INDESIT company

Model type:
IDC75EU

Commercial code:
F062979

07427-20 Exploded views

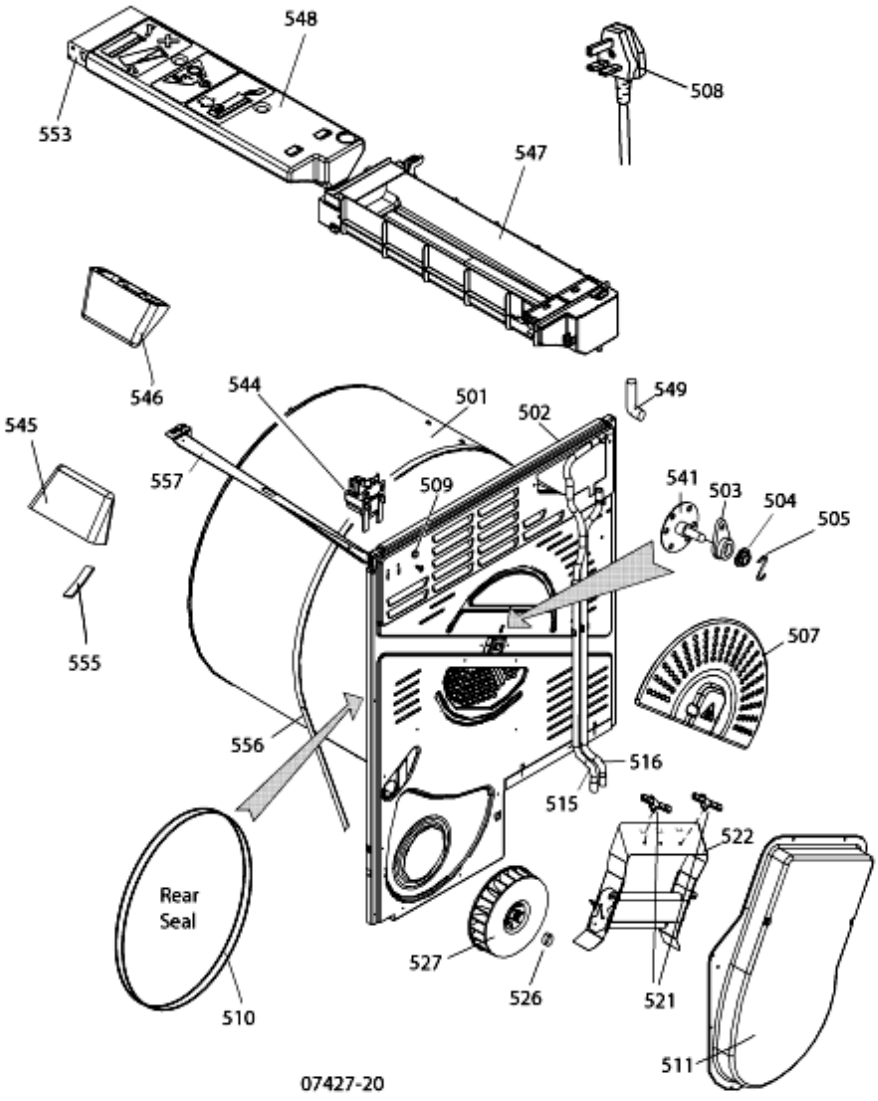
n4410k02: TUMBLE DRYER HEATER CHANGE

FROM SERIAL NUMBER 01112.0000 A NEW HEATER WITH A COLOMBO CONNECTOR HAS BEEN USED IN PRODUCTION.
THIS NEW HEATER IS NOT INTERCHANGEABLE WITH THE PREVIOUS ONE.

n4411j00: PATTERN DRUM INTRODUCED

FROM OCTOBER 2011 A PATTERN DRUM HAS BEEN USED IN PRODUCTION.
THE PATTERN DRUM IS INTERCHANGABLE WITH THE PREVIOUS PLAIN DRUM.
ONCE STOCKS OF THE PLAIN DRUM ARE EXHAUSTED.
THE PATTERN DRUM WILL BE THE SERVICE SPARE.

NOTE
TWO PLAIN DRUMS WERE USED IN PRODUCTION.
THE DRUM SHAFT CAN ONLY BE REPLACED IF THE ORIGINAL DRUM TO SHAFT FIXING IS SCREWED. IF THE DRUM SHAFT IS RIVETED TO THE DRUM, THE COMPLETE DRUM HAS TO BE REPLACED.

n4414g00: DRUM SHAFT REPAIR KITS

THERE ARE 2 TUMBLE DRYER DRUM SHAFT KITS.

C00113038 DRUMS WHERE THE DRUM SHAFT IS SCREWED
C00305794 DRUMS WHERE THE DRUM SHAFT IS RIVETTED.
THE CORRECT KIT MUST ALWAYS BE FITTED.
BOTH KITS CONSIST OF THE DRUM SHAFT/SUPPORT, DRIVE PIN FIXING SCREWS and REAR BEARING.
STARTING FROM JUNE 2014 THE DRUM SEALS WHICH WERE INCLUDED IN KIT C00113038 HAVE BEEN REMOVED.

n4413j00: BREAKING BELTS

To overcome the issue of breaking belts the 6 Rib belt has been replaced by the 8 rib belt C00300793

07484-06 Exploded views

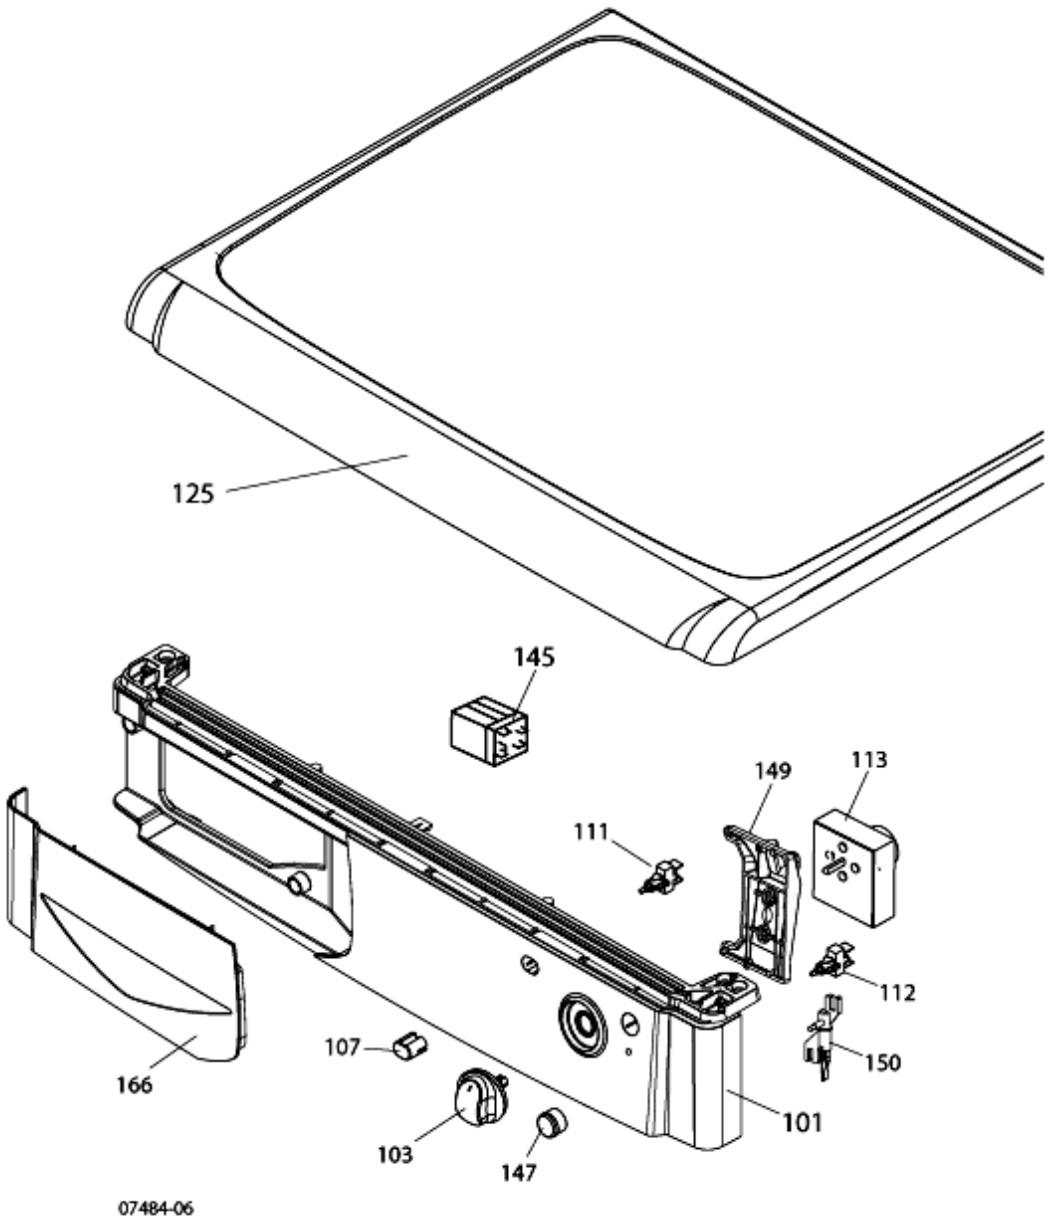
n4411i00: CONDENSER REVERSING TIMERS

2 TIMERS HAVE BEEN USED IN PRODUCTION. INVENSYS AND BITRON (ELBI).
CHECK THE TIMER FITTED TO THE MACHINE BEFORE ORDERING.

THE TIMERS ARE INTERCHANGEABLE, BUT THE TIMER CONECTIONS ARE LABELLED DIFFERENTLY.
THE ALTERNATE WIRING CONNECTIONS ARE SHOWN IN THE WIRING DIAGRAM FOUND IN THE SERVICE MANUAL OR WIRING DIAGRAM.

12721-15 Exploded views

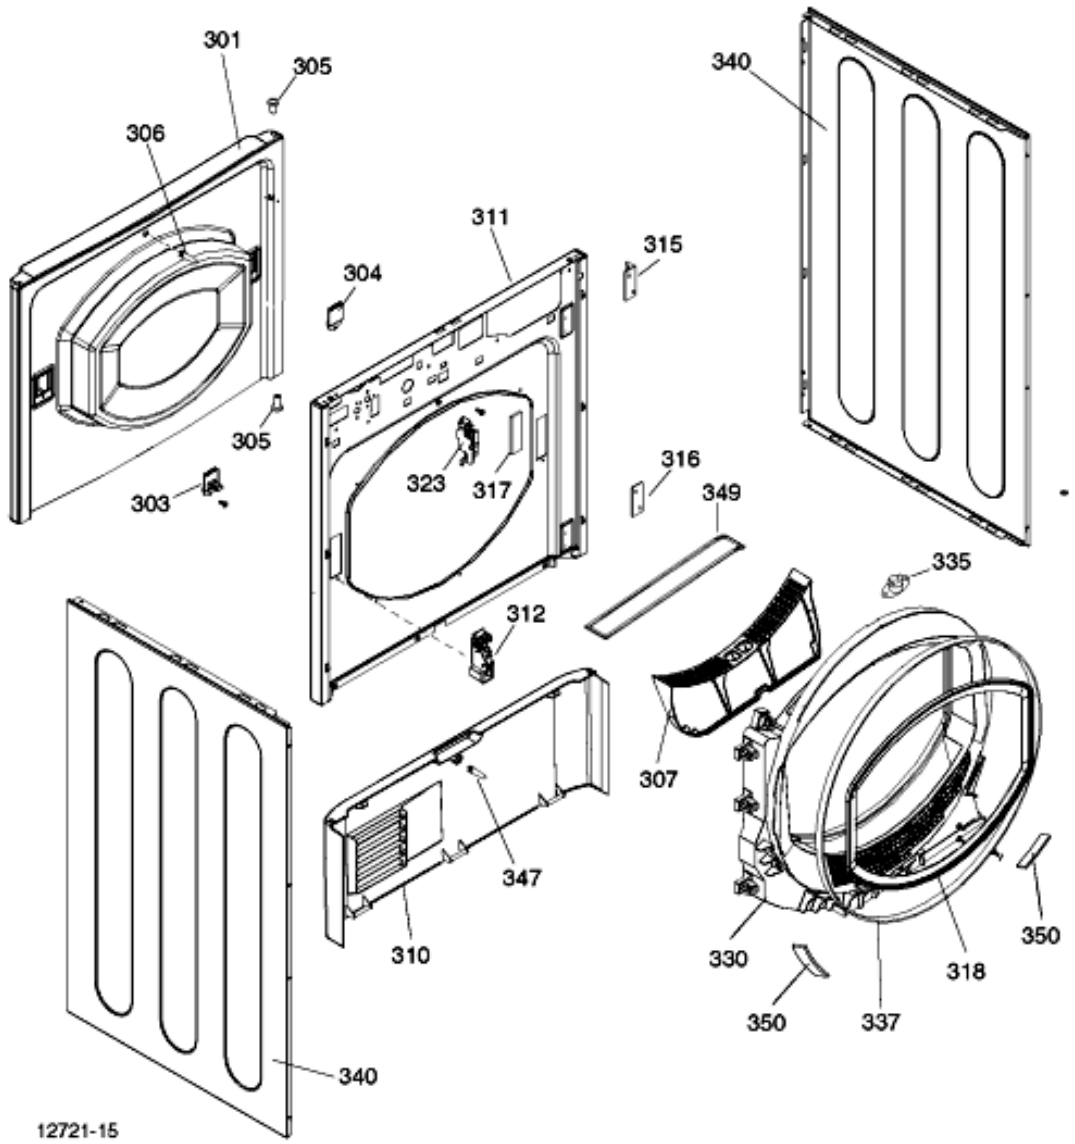
n4409i01: Bearing Pad Grooved

'C' Energy Condenser Tumble Dryers.
From serial number 90817.0001 the quantity of bearing pads C00255284 fitted on production was reduced fro 5 to 4.
'B' Energy Condenser Tumble Dryers are not effected and will continue to use 5 bearing pads

n4411g07: CONDENSER FRONT AIR DUCT COLOUR CHANGE

FROM JUNE 2011 THE FRONT AIR DUCT FITTED TO CONDENSER TUMBLE DRYERS CHANGED IN PRODUCTION FROM GREY TO WHITE.
SELECTED THE CORRECT PART BY DESCRIPTION IN THE PARTS LIST

n4414b01: CONDENSER MECHANICAL DRYER FRONT THERMOSTAT

FROM JULY 2013 THE FRONT AIR DUCT THERMOSTAT IS NO LONGER USED IN PRODUCTION>

n4414b02: DOOR RELAY REPLACED IN PRODUCTION

DURING OCTOBER 2013 THE DOOR RELAY AND ASSOCIATED DOOR SWITCH FITTED TO CERTAIN TUMBLE DRYERS IS NO LONGER USED IN PRODUCTION.
A BITRON DOOR SWITCH/LOCK ASSEMBLY REPLACES THE ORIGINAL DOOR RELAY AND DOOR SWITCH.
NOTE DURING OCTOBER 2013 THE TYPE OF DOOR LOCK WILL HAVE TO BE VISUALLY IDENTIFIED AS BOTH THE ORIGINAL DOOR LOCK AND RELAY AND THE BITRON DOOR SWITCH/LOCK HAVE BEEN USED IN PRODUCTION.
